Town of Kittery Planning Board Meeting February 14, 2019

ITEM 2 - 459 U.S. Route One – Site and Subdivision Final Plan Review

**RE: Town of Kittery, Planning Board Services
Final Site Plan Review Application
The Homestead 459 U.S. Route 1 (Tax Map 60, Lot 24)
CMA #591.121**

OVERALL SITE PLAN
THE HOMESTEAD
459 US ROUTE 1 KITTEY, MAINE

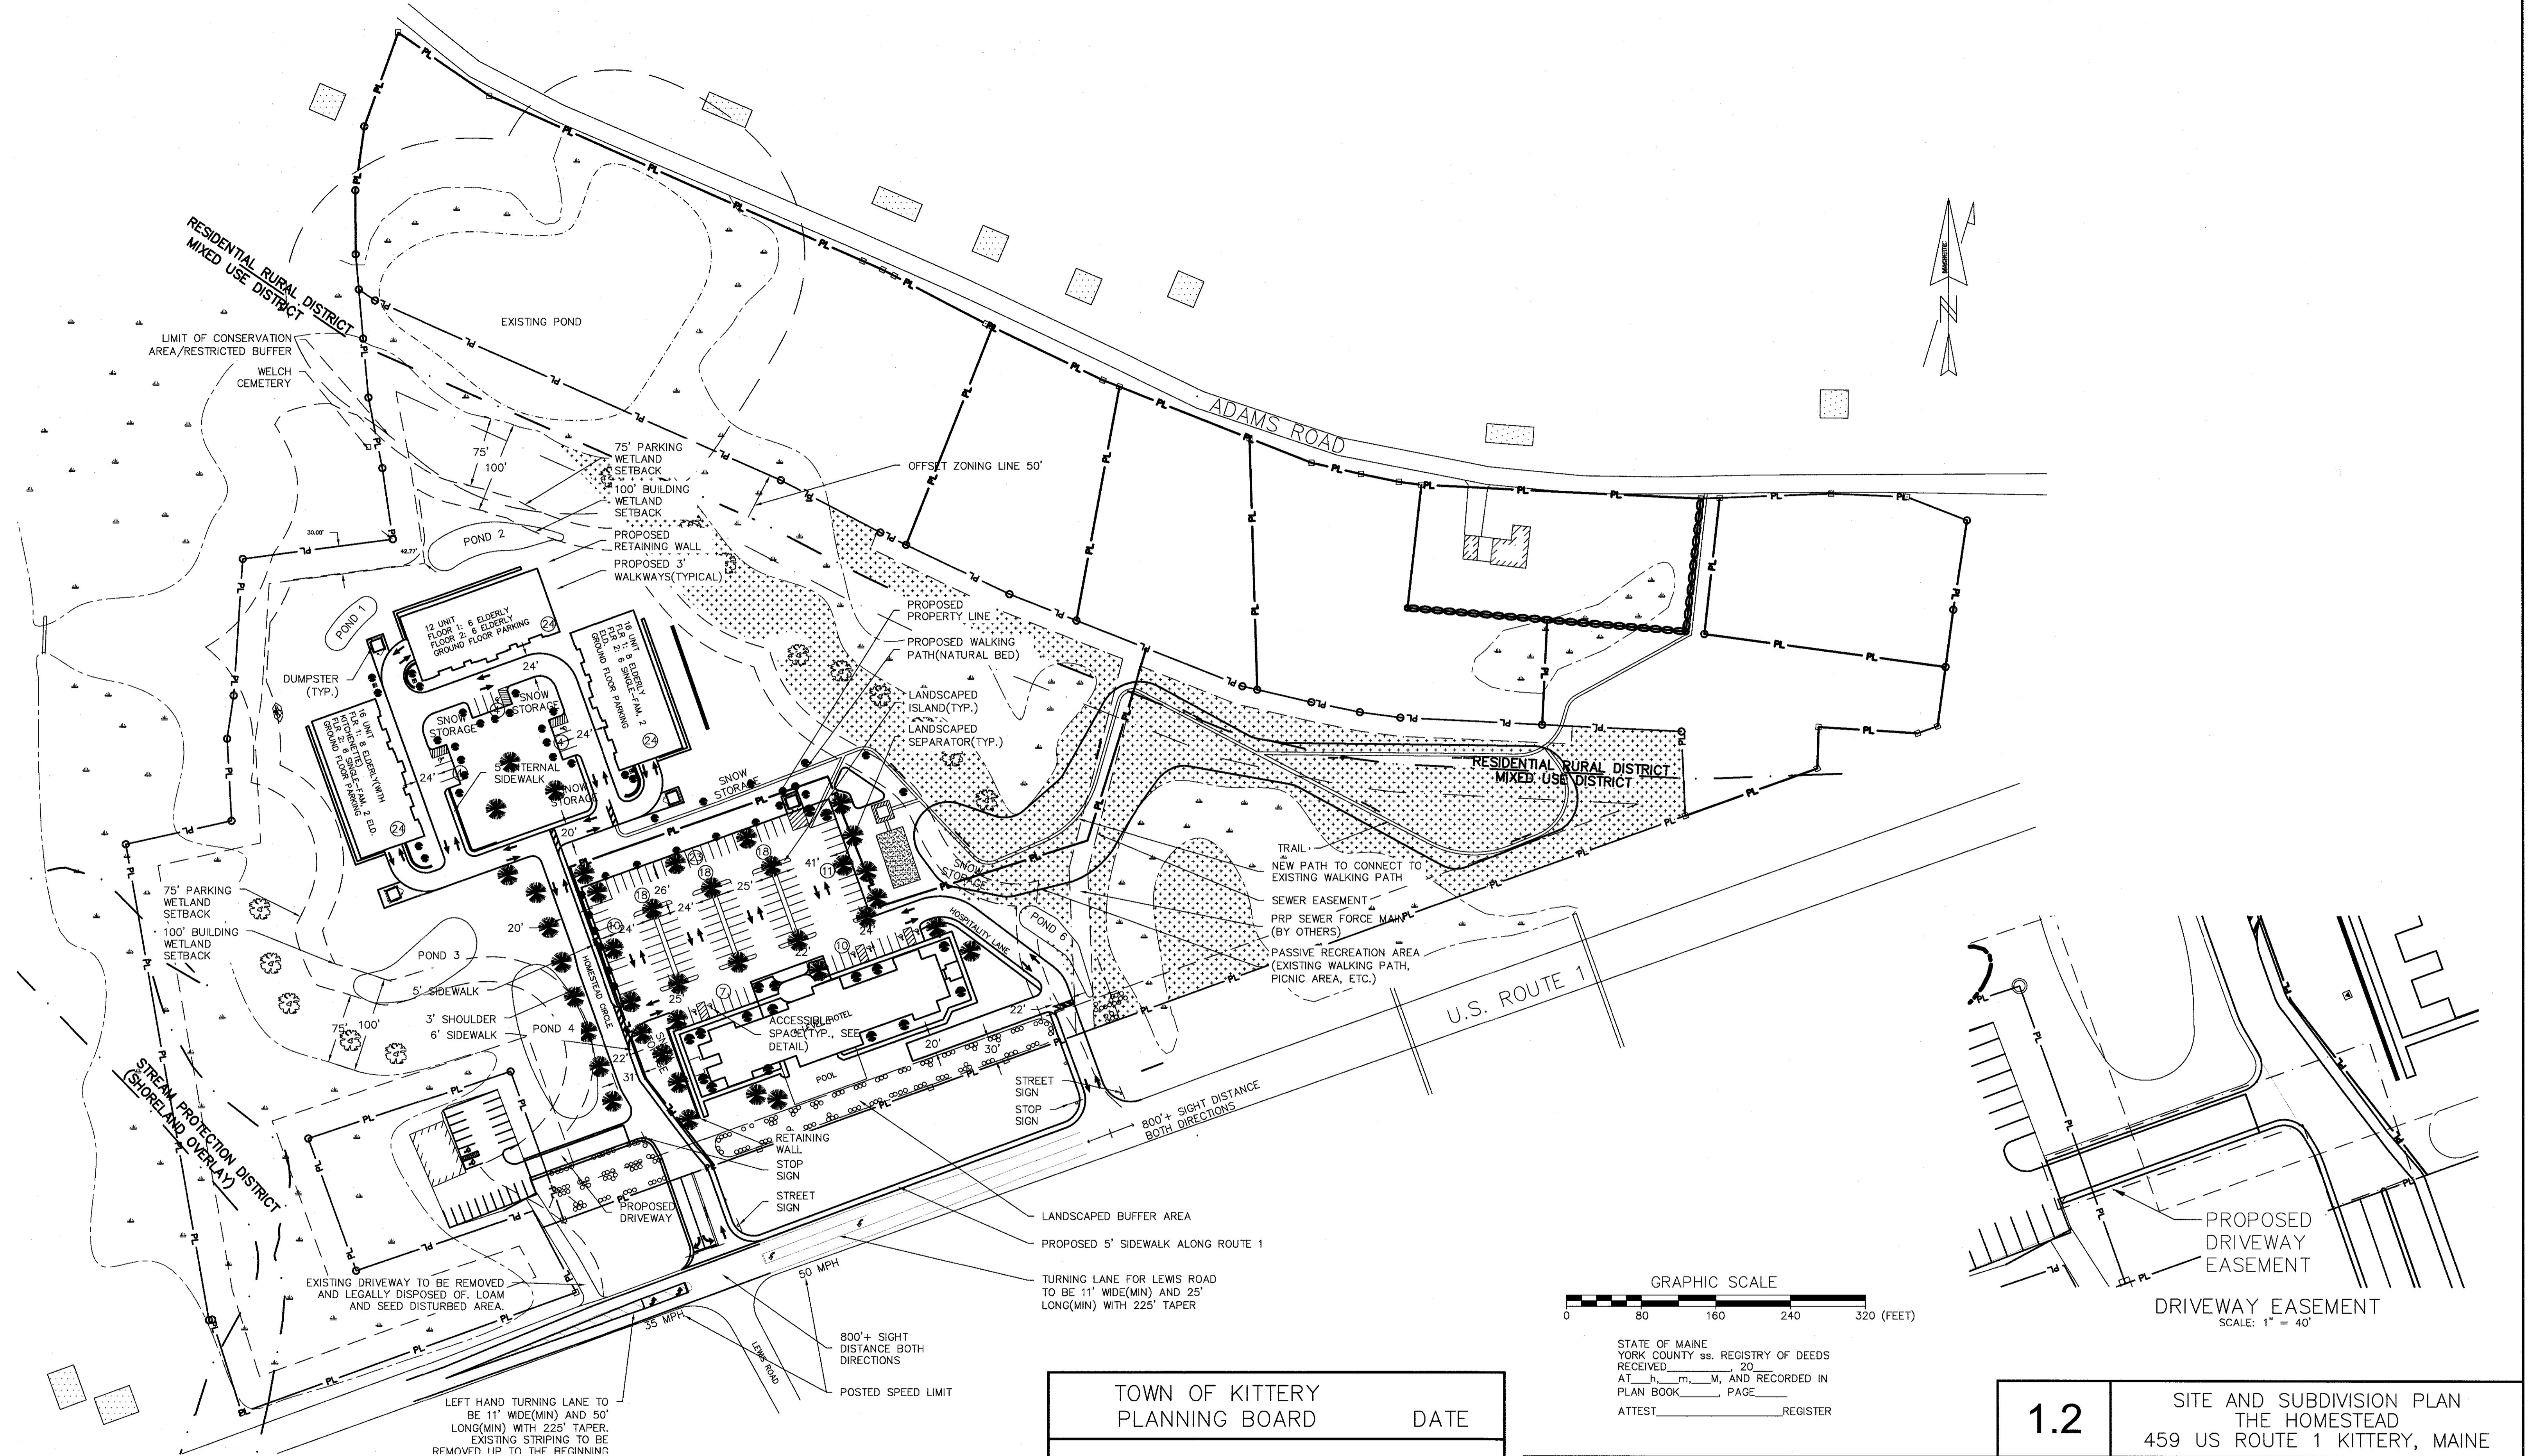
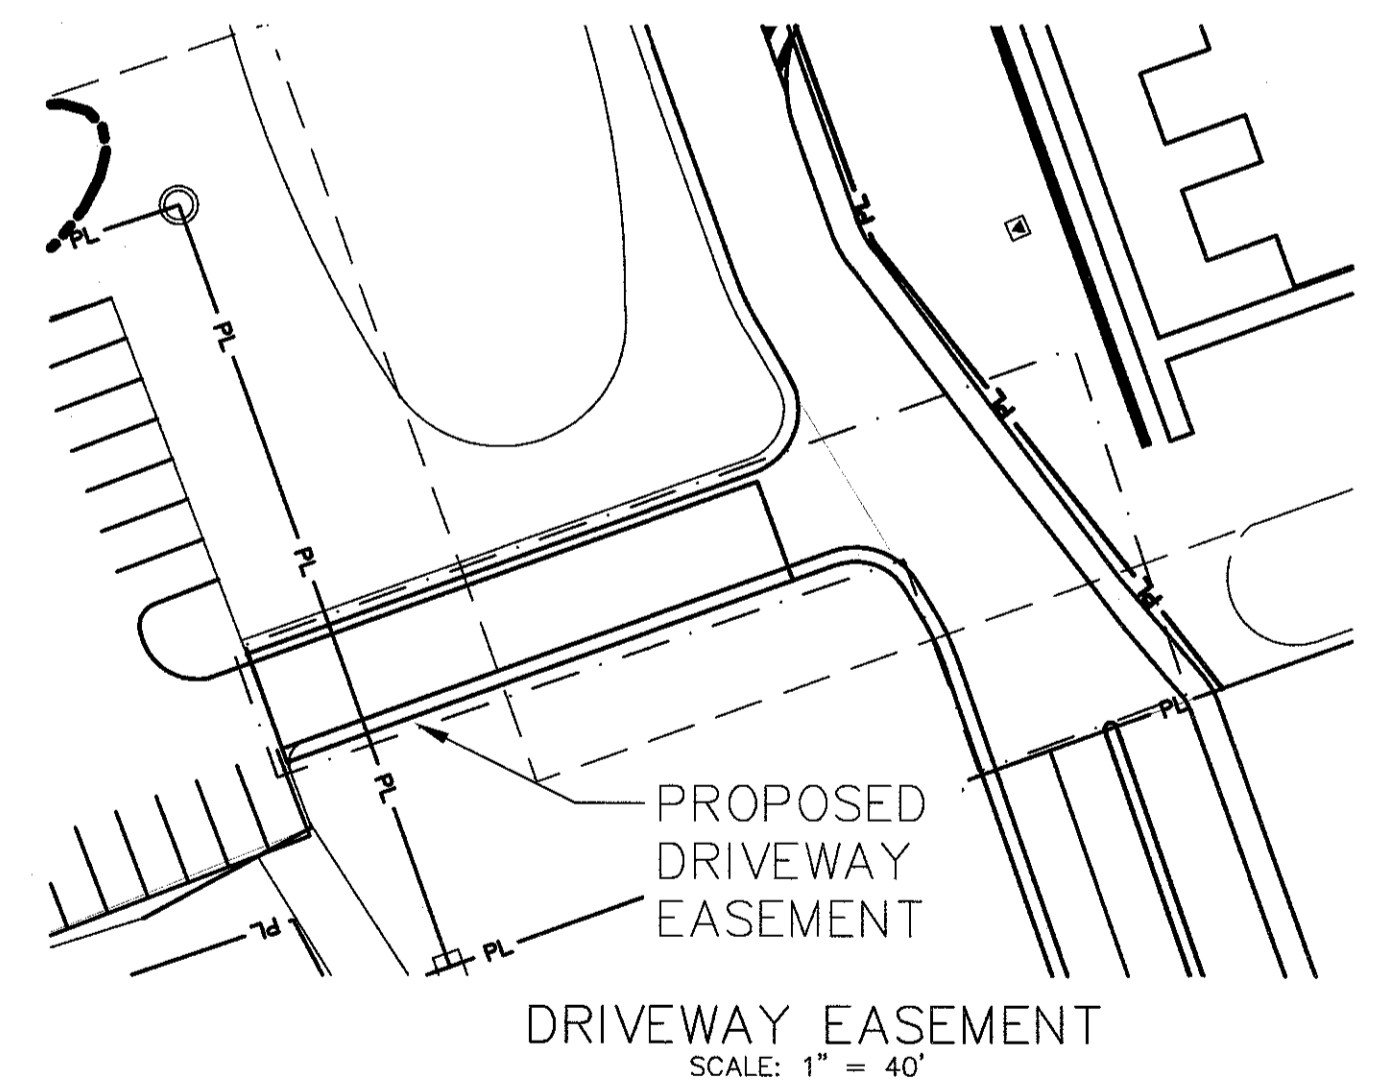
D.2. In note 4 on Sheet 1.1, the applicant should list the provided setbacks, frontage and lot size in addition to the required zoning information. *(We note that this comment was included in our previous review from November 2018 and was not addressed).*

WATER SERVICE DETAIL
(NTS)

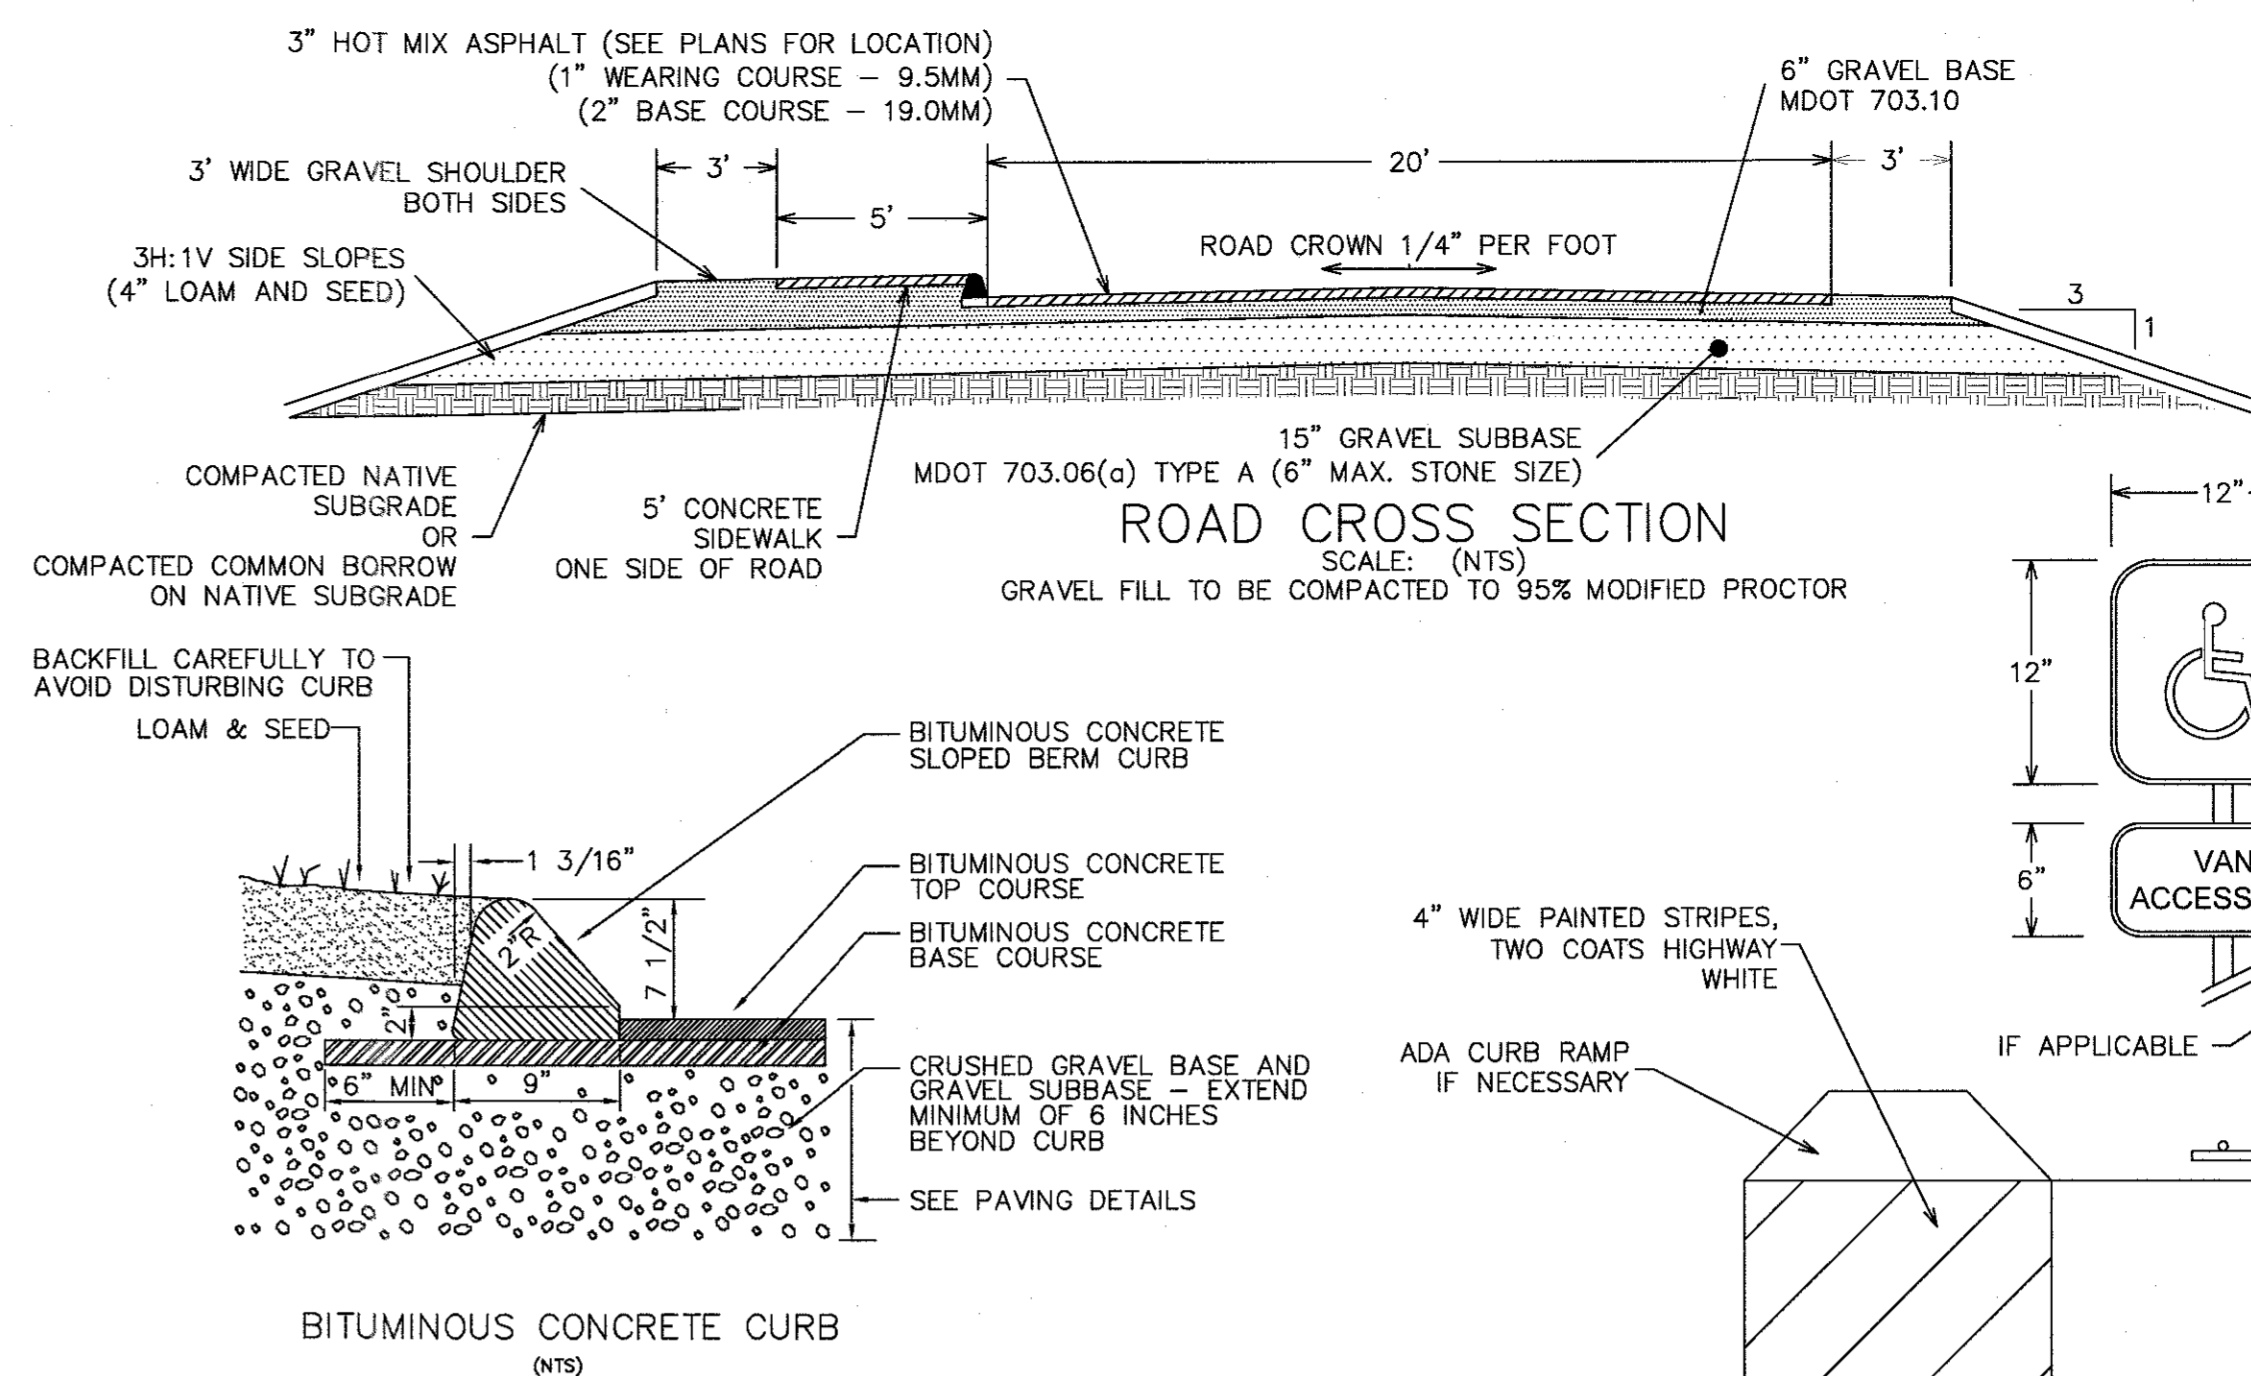
16.8.6.1 The water service detail indicates a curb stop but the plans show gate valves. Are there curb stops proposed? If so, please indicate their locations on the plans. IF there are no curb stops proposed, please amend the detail to indicate that gate valves are

being used. *(We note that this comment was included in our previous review from November 2018 and was not addressed).*

ACCESSIBLE PARKING SPACE DETAIL
ISLE SHALL BE 5' WIDE FOR AUTOMOBILES OR 8' WIDE FOR VANS (NTS)

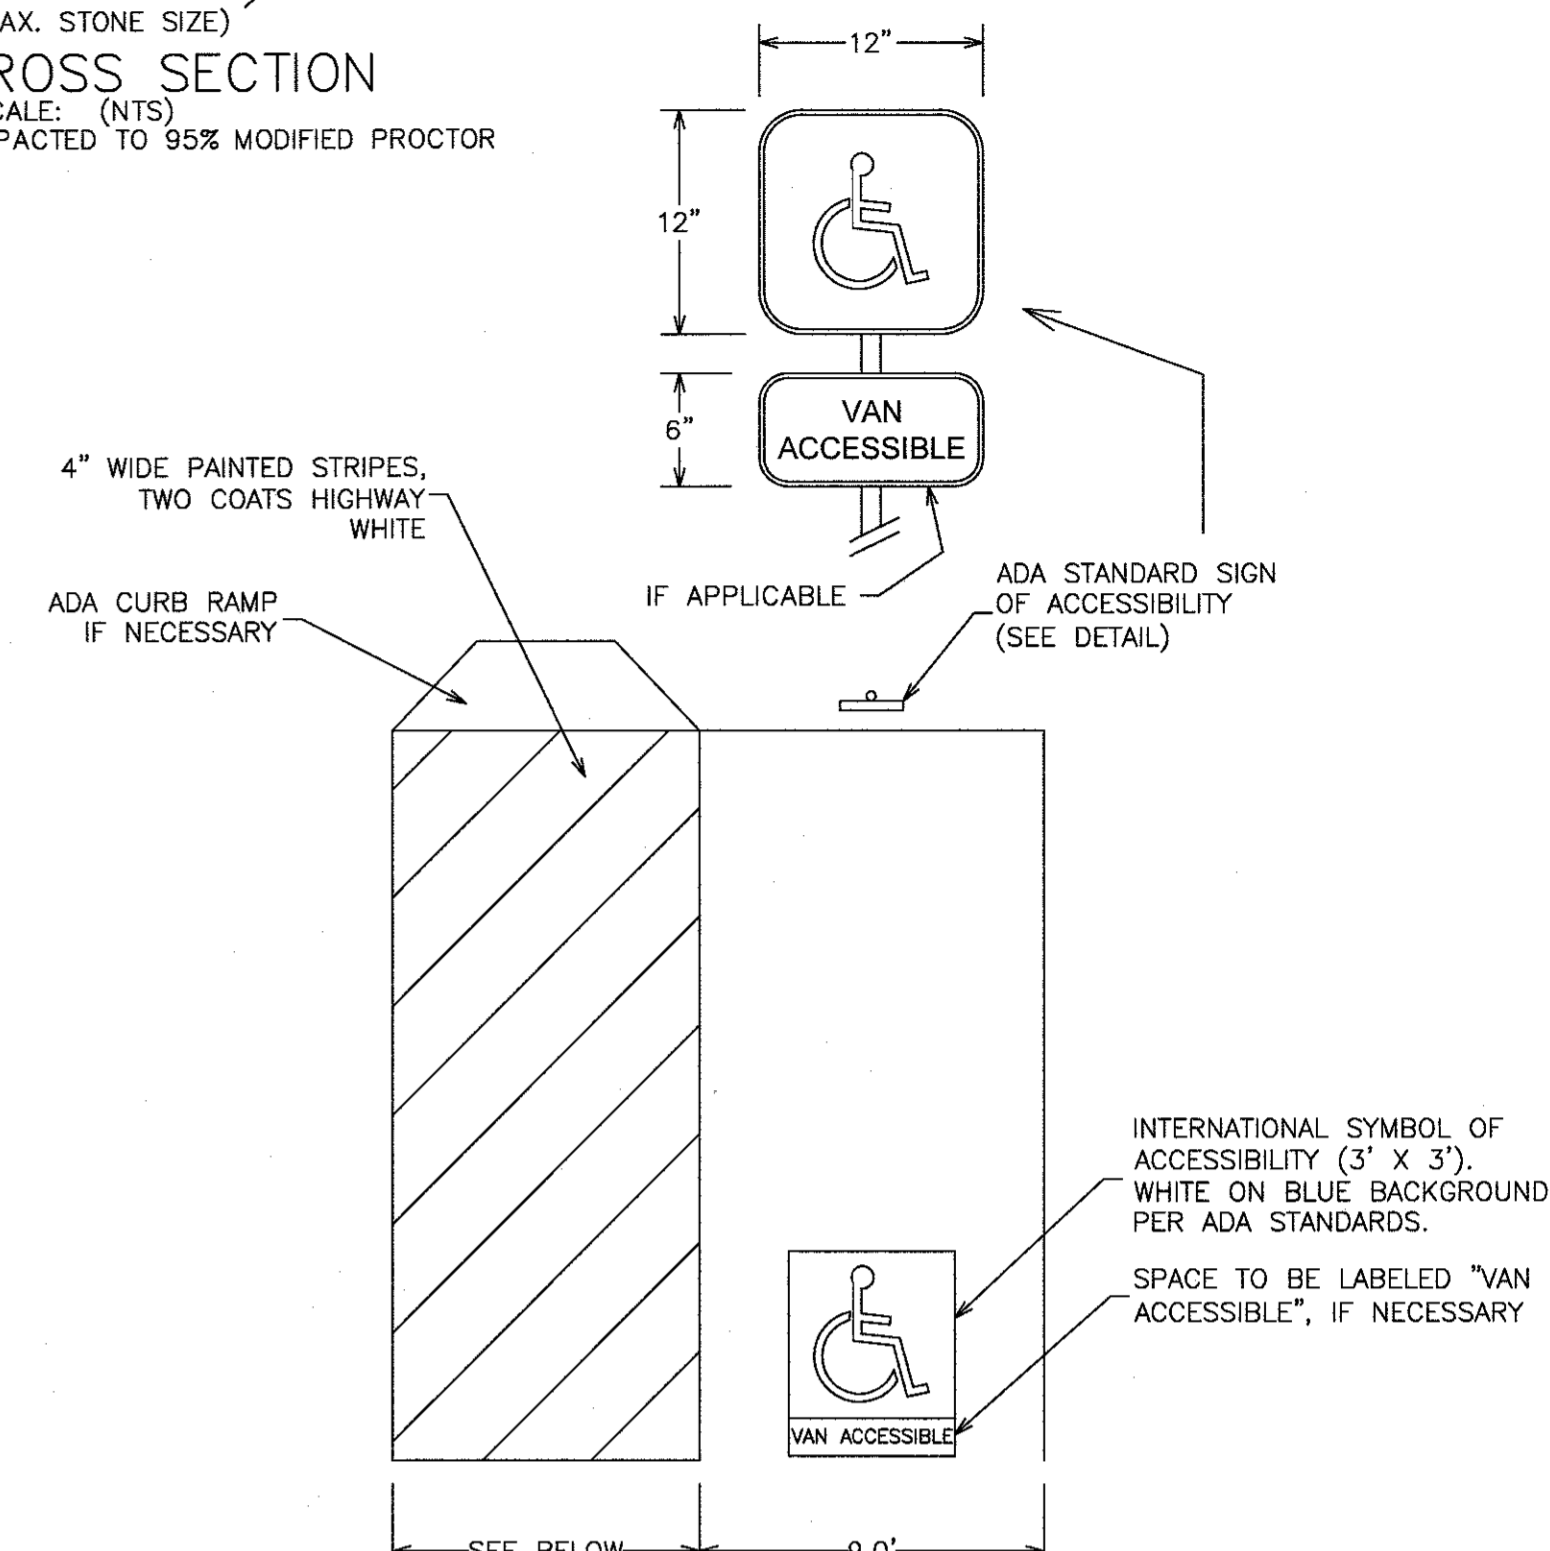
16.8.9.4.D.I.1 The applicant should show dimensions of the accessible parking spaces on the plans. *(We note that this comment was included in our previous review from November 2018 and was not addressed).*
